From: Pederson Ronda M (AREVA NP INC) [Ronda.Pederson@areva.com]
Sent: Tuesday, March 31, 2009 8:16 PM
To: Getachew Tesfaye
Cc: BENNETT Kathy A (OFR) (AREVA NP INC); DELANO Karen V (AREVA NP INC); VAN NOY Mark (EXT); HEDRICK Gary E (AFS)
Subject: Response to U.S. EPR Design Certification Application RAI No. 155, Supplement 1
Attachments: RAI 155 Supplement 1 Response US EPR DC.pdf

Subject: Response to U.S. EPR Design Certification Application RAI No. 155, FSAR Ch. 3

QUESTIONS for Structural Engineering Branch 2 (ESBWR/ABWR Projects) (SEB2)

Figure 03.08.01-2-1
Interface Between RBIS and Common Basemat Structure

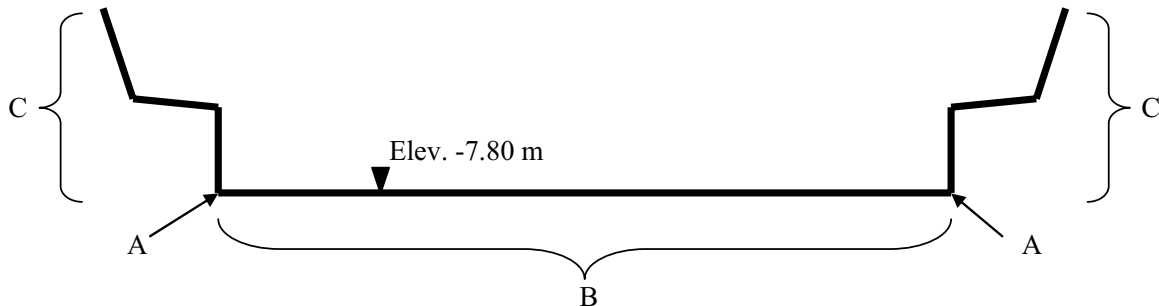
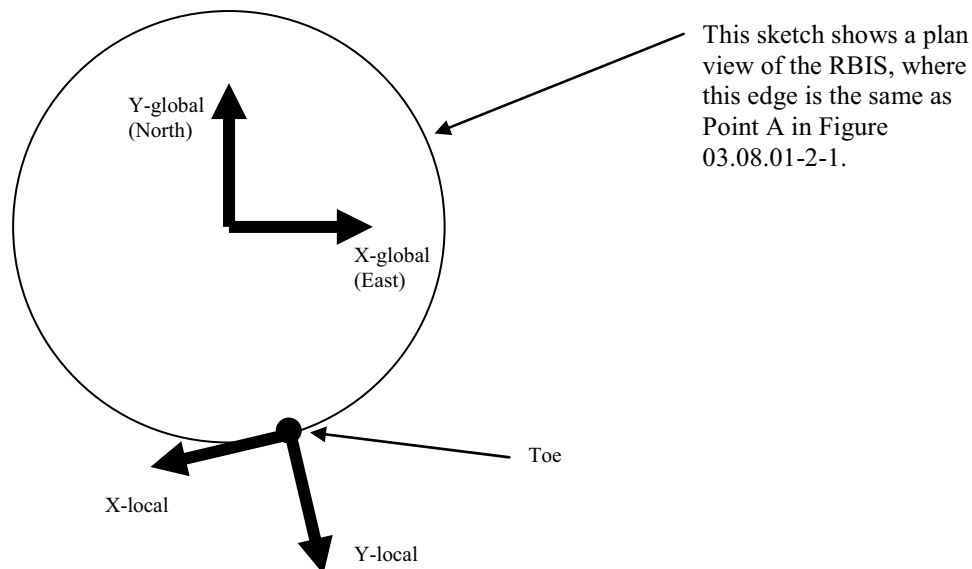
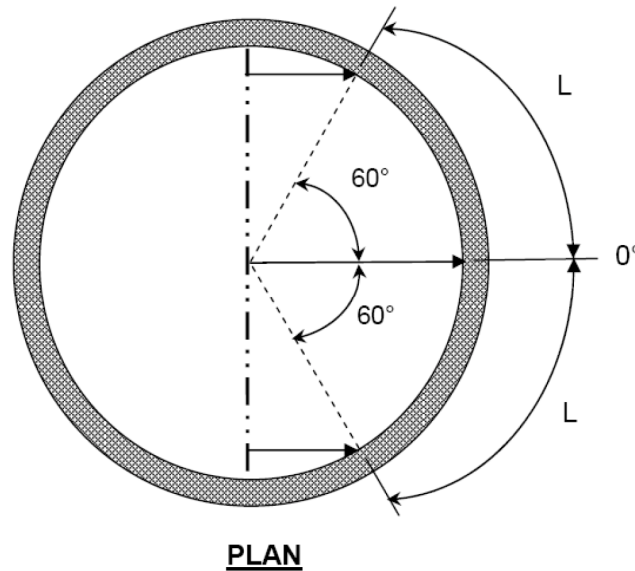
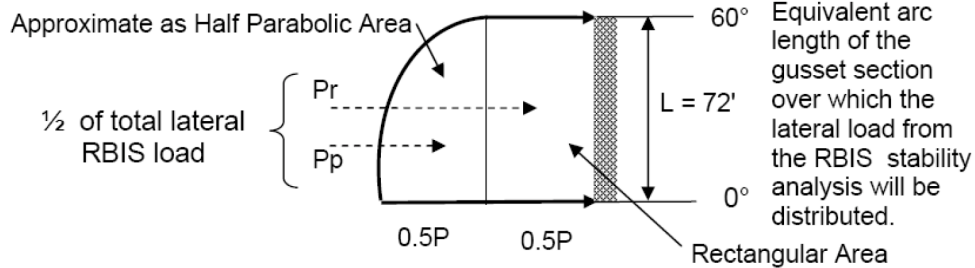
Question 03.08.01-2:

Response to Question 03.08.01-2:

- The nodes around the periphery of the circular base (see Point A in Figure 03.08.01-2-1) were fixed against translation in all three directions. These nodes are free to rotate in all three directions.
- The remaining nodes located on the bottom of the circular base (see Point B in Figure 03.08.01-2-1) were fixed against translation in both lateral directions. These nodes are free to rotate in all three directions, and to translate in the vertical direction.
- The remainder of the nodes along the interface surface (see point C in Figure 03.08.01-2-1) are free to translate and rotate in all directions. This is conservative since these surfaces, if restrained in the model, would provide additional resistance against sliding and overturning.

- The vertical support node (see Point A in Figure 03.08.01-2-1) which carries the largest compressive reaction load is identified. This is the point that the RBIS is trying to overturn about (i.e., the “toe”) for the current loading condition.

- A local coordinate system (CS) is established. The origin of the local CS is located at the toe. The X-axis of the local CS is located tangent to the periphery of the RBIS foundation. The direction of the X-axis is such that a moment about this axis is positive if the moment is toward the center of the RBIS, and negative otherwise. See Figure 03.08.01-2-2.

For the haunch, F_{slide} was applied to a 120° arc of the haunch. Therefore, the entire sliding load is assumed to be carried by one-third of the total length of the haunch. The intensity of F_{slide} applied to the haunch varied along the length from a maximum ($\cos 0^\circ = 1.0$) at the center of the arc to a minimum ($\cos 60^\circ = 0.5$) at the edges of the arc. See Figure 03.08.01-2-3 for clarification.

Figure 03.08.01-4-1
Jurisdictional Boundaries

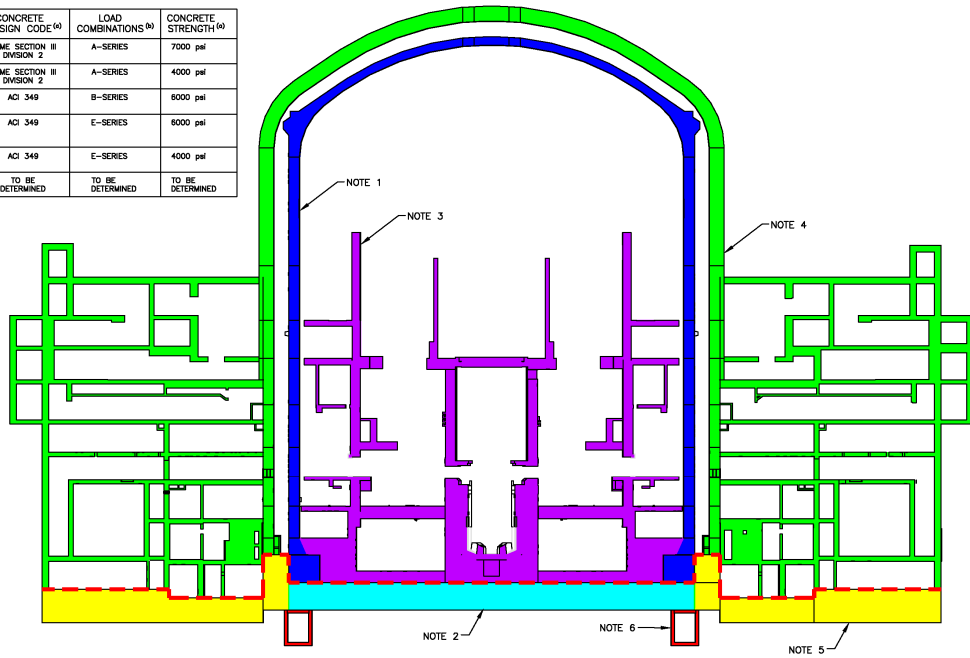
1. Since the RCB is founded on the same NI basemat as several other seismic category I structures, explain where is the ASME containment jurisdictional boundary defined for the EPR plant which must satisfy the code requirements of the ASME Section III, Division 2. The response should consider the fact that the containment basemat is integrally connected to the rest of the NI foundation, and thus additional peripheral volume of concrete and anchorage of the containment shell reinforcement beyond the containment wall should be included in the jurisdictional boundary. In addition, AREVA is requested to confirm that all loads (e.g., wind, lateral earth pressure, etc.) arising from the evaluation of the common basemat outside the rules of ASME Code Section III, Division 2, are considered in combination with those specified for the ASME Code Section III, Division 2 basemat.

1. ASME Section III Division 2 (subarticle CC-1140) does not provide specific guidance on where to locate the jurisdictional boundary between ASME Section III Division 2 and other design codes (i.e., ACI 349). As per ASME Section III Section NCA (subparagraph NCA-3254.2), the jurisdictional boundary shall be specified in the Design Specification. This indicates that the specific location of the jurisdictional boundary is to be determined by the designer. The jurisdictional boundary selected for the U.S. EPR, as applicable to the common basemat, is a cylinder aligned with the outside face of the reactor containment building wall. The complete jurisdictional boundary is shown in Figure 03.08.01-4-1. Together, the turquoise and blue areas form the portions of the common basemat structure under the jurisdiction of ASME Section III Division 2. All loads arising from the evaluation of the common basemat outside the rules of ASME Code Section III, Division 2, are considered in combination with those specified for the ASME Code Section III, Division 2 basemat. For example, when analyzing load combinations for design of the containment

Figure 03.08.03-1-1
Reactor Vessel Support Ring

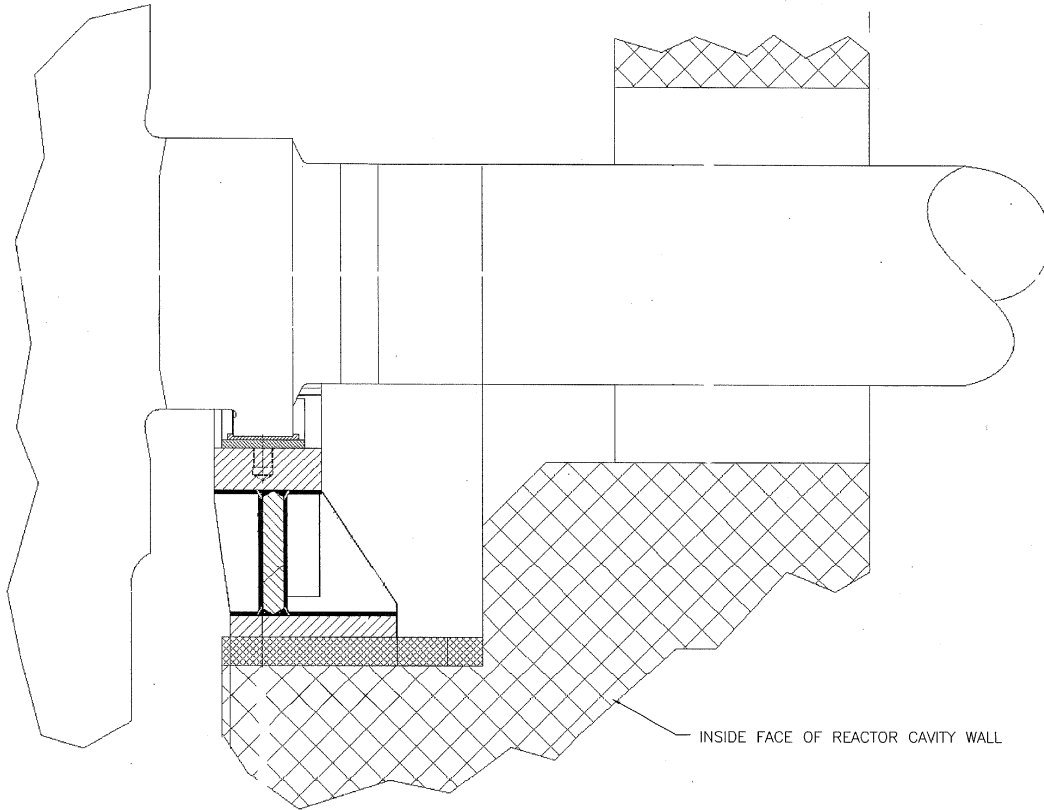
FSAR Section 3.8.3.1.1 provides some description of the reactor vessel (RV) support structure and reactor cavity. Since this description and associated figures are not sufficient to understand the structural elements, connections, and load path from the components to the containment internal structures, provide the following additional information:

1. Provide additional details which show how the RV ring is embedded into the concrete and the anchorage details.
2. Provide details of the components described in the second paragraph of FSAR Section 3.8.3.1.1 which include the large penetrations in the circular RV support concrete wall, permanently installed cavity seal ring, and neutron shield assembly resting on the embedded ring at the top of the wall.
3. Provide details of the embedment plates, baseplates, grout (if applicable) and anchorages for the RV; vertical and horizontal supports of the steam generators, reactor coolant pumps, and pressurizers; and the polar crane steel plate support brackets.

2. The large penetrations in the circular RPV concrete wall are block-outs that allow the legs of the RCS to pass through. There is a block-out for each leg of the RCS. See Figure 03.08.03-1-1.

Figure 03.08.05-4-1
Seismic Soil Pressure Distribution used in the Design of Foundation Walls

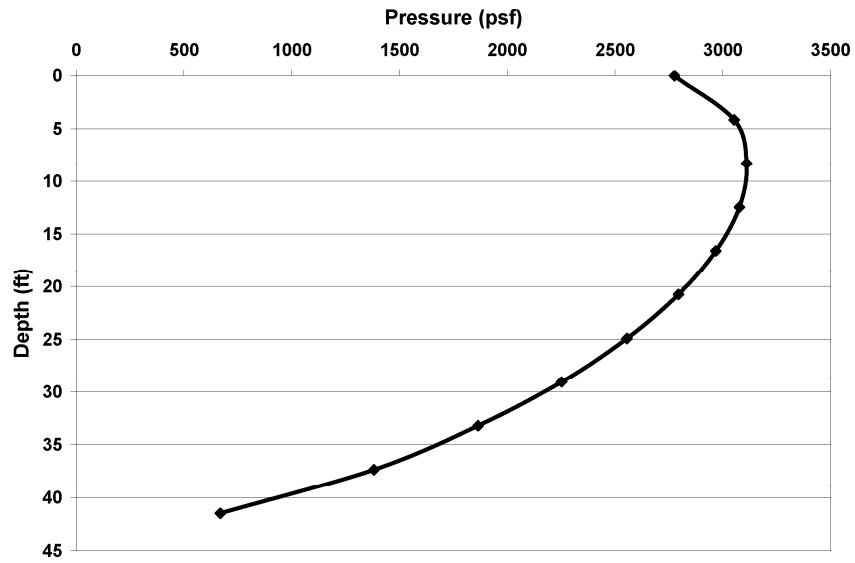
5. If lateral earth pressure loads are needed to resist the structure sliding and overturning, presumably at the same time, provide the seismic pressure distribution used in the design of the foundation walls and compare them to the maximum calculated soil pressure load distribution from the sliding and overturning seismic analysis.

5. Seismic soil pressure used in the design of foundation walls varies with depth with a maximum of 3.11 ksf (see Figure 03.08.05-4-1 for pressure distribution). Maximum bearing pressure from seismic sliding analysis is 34.56 ksf (see Figure 03.08.05-4-2 for bearing pressure distribution under sliding event).

Figure 03.08.05-17-1
Emergency Power Generating Building Reinforcement

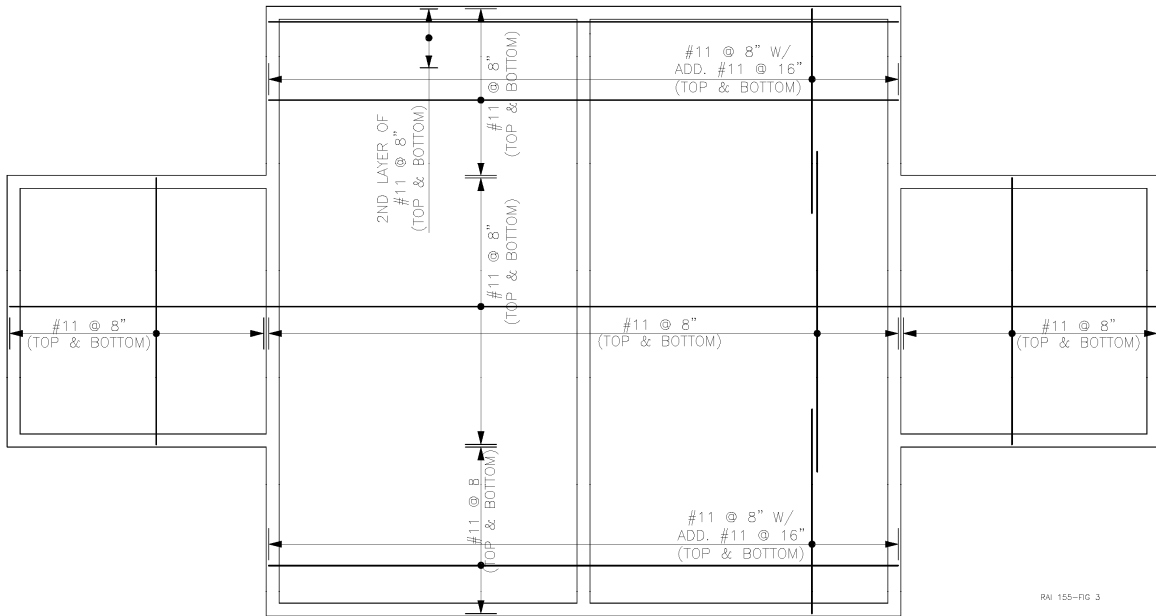
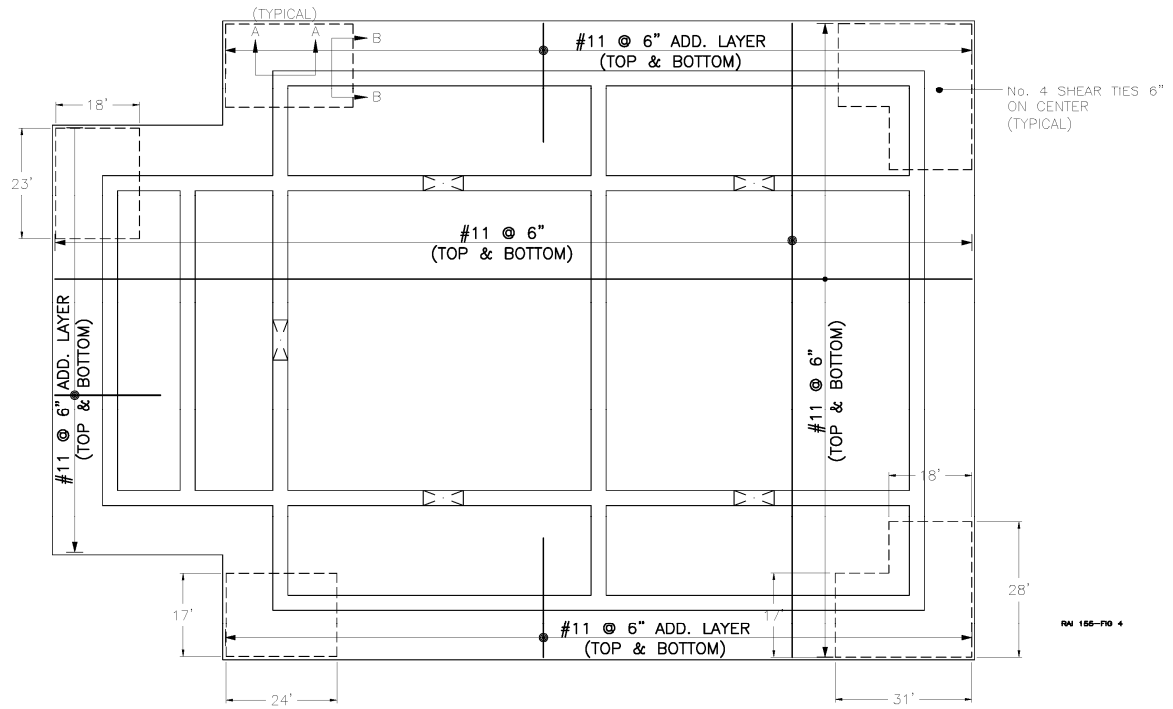
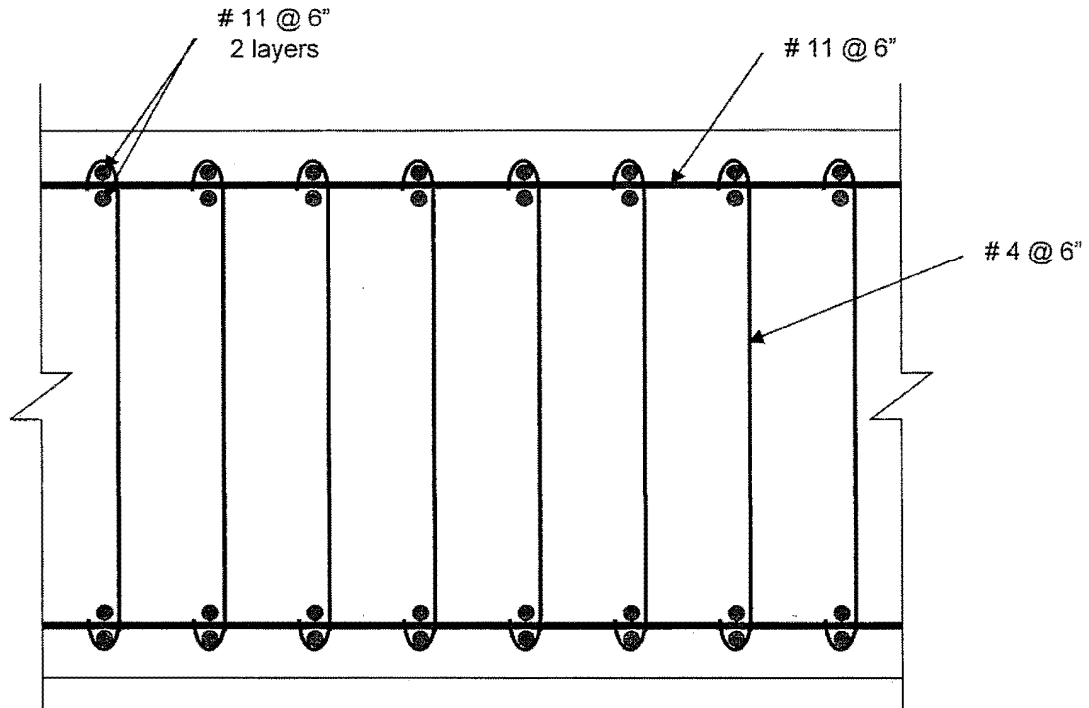
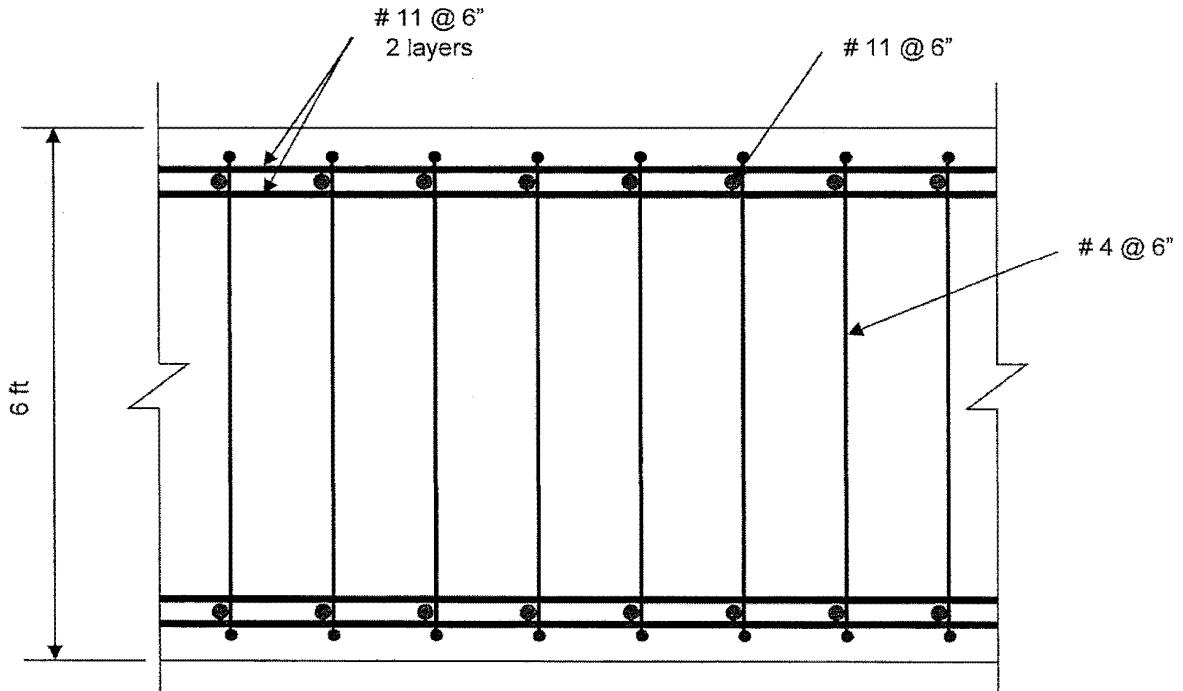
FSAR Section 3E.2.1 for the EPGB foundations and FSAR Section 3E.3.1 for the ESWB foundations describe the basemat typical reinforcement configurations in FSAR Figures 3E.2-3 and 3E.3-3, respectively. These figures indicate the horizontal reinforcement pattern for each foundation design, but do not indicate whether this reinforcement is in the top or bottom of the slab. Provide additional figures showing key cross sections of the slabs that indicate the size, location and spacing of the top and bottom reinforcement, as well as any vertical reinforcement. Also, please reconcile the difference in the reinforcement for the NI foundation specified in FSAR Table 3E.1-37 and shown in FSAR Figure 3E.1-75.

The reinforcement shown in U.S. EPR FSAR Tier 2, Figures 3E.2-3 and 3E.3-3, is required on both top and bottom faces. The information provided in the U.S. EPR FSAR is limited due to scale. The specific requested detail is provided in Figures 03.08.05-17-1 through 03.08.05-17-4.

No vertical (shear) reinforcement is required for the Emergency Power Generating Building (EPGB) foundation. The vertical (shear) reinforcement is not required for the revised Essential Service Water Building (ESWB) foundation configuration. The remaining information regarding the ESWB requested by this RAI was also part of the subject matter of RAI 130, Question 03.07.02-27. Therefore, this portion of the response will be addressed in the response to RAI Batch 130 Question 03.07.02-27, which will be provided as committed by the AREVA NP response to RAI 130.
